9.5 Other Auxiliary Systems

The information in this section of the reference ABWR DCD, including all subsections, tables, and figures, is incorporated by reference with the following departures and supplements.

STP DEP 1.1-2 (Table 9.5-5, Figure 9.5-2)	STD DEP 9.5-3
STD DEP 8.3-1	STD DEP 9.5-4
STD DEP 9.4-2 (Table 9.5-5)	STP DEP 9.5-6 (Figure 9.5-6)
STD DEP 9.5-1	STP DEP 9.5-7 (Table 9.5-5)
STD DEP 9.5-2 (Figure 9.5-3, replaced entire figure)	STD DEP Admin

Figure 9.5-3 – Lower Drywell Flooder System Arrangement/Configuration

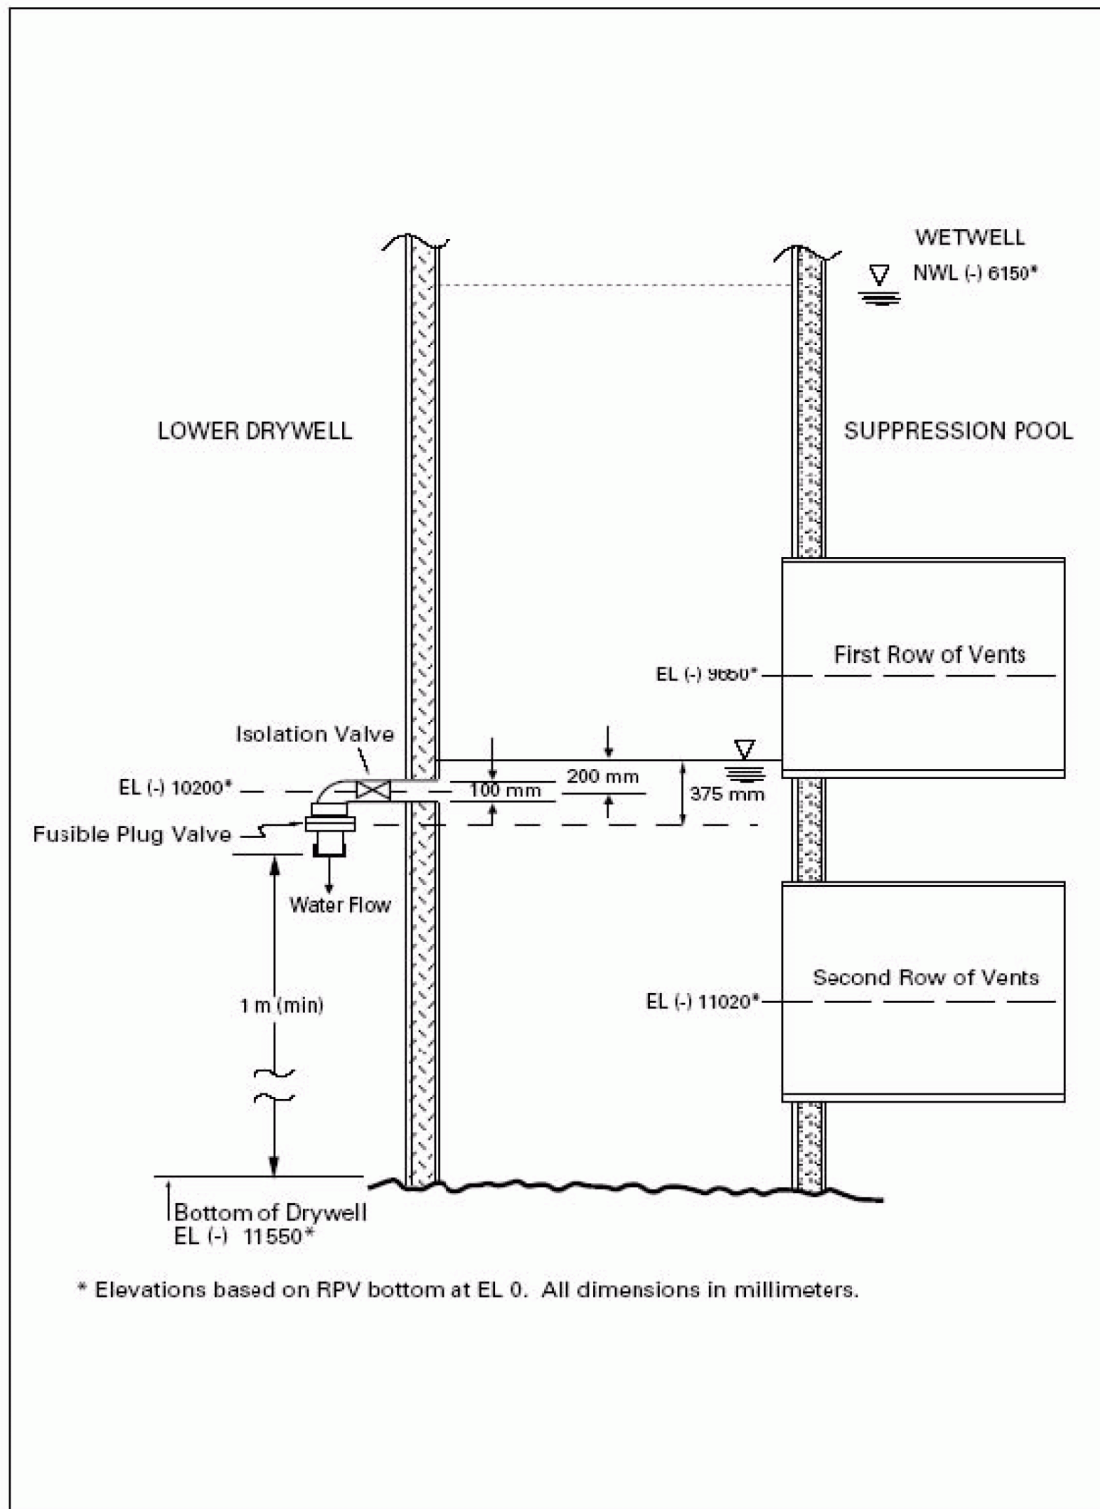
STD DEP 9.5-2

The LDF, shown schematically in Figure 9.5-3, provides a flow path for suppression pool water into the lower drywell area during severe accident scenario that leads to core meltdown, vessel failure, and deposition of molten corium on the lower drywell floor. Molten corium is a molten mixture of fuel, reactor internals, the vessel bottom head and control rod drive components. The flow path is opened when the lower drywell airspace temperature reaches $260^{\circ}\text{C} \pm 10^{\circ}\text{C}$.

The LDF consists of ten pipes that run from the vertical pedestal vents into the lower drywell. Each pipe ~~contains~~ has an isolation valve and a fusible plug valve connected to the end of the pipe that extends into the lower drywell ~~by a flange~~. The fusible plug valves open when the drywell air space ~~(and subsequently the fusible plug)~~ temperature reaches $260^{\circ}\text{C} \pm 10^{\circ}\text{C}$. When the fusible plug valves open, a minimum of 10.5 L/s of suppression pool water will be supplied through each flooder pipe (105 L/s total) to the lower drywell to quench the corium, flood the lower drywell and remove corium decay heat, which is estimated at 1% of rated thermal power. The flow rate is based on a minimum hydrostatic head of 200 mm above the flooder pipe inlet
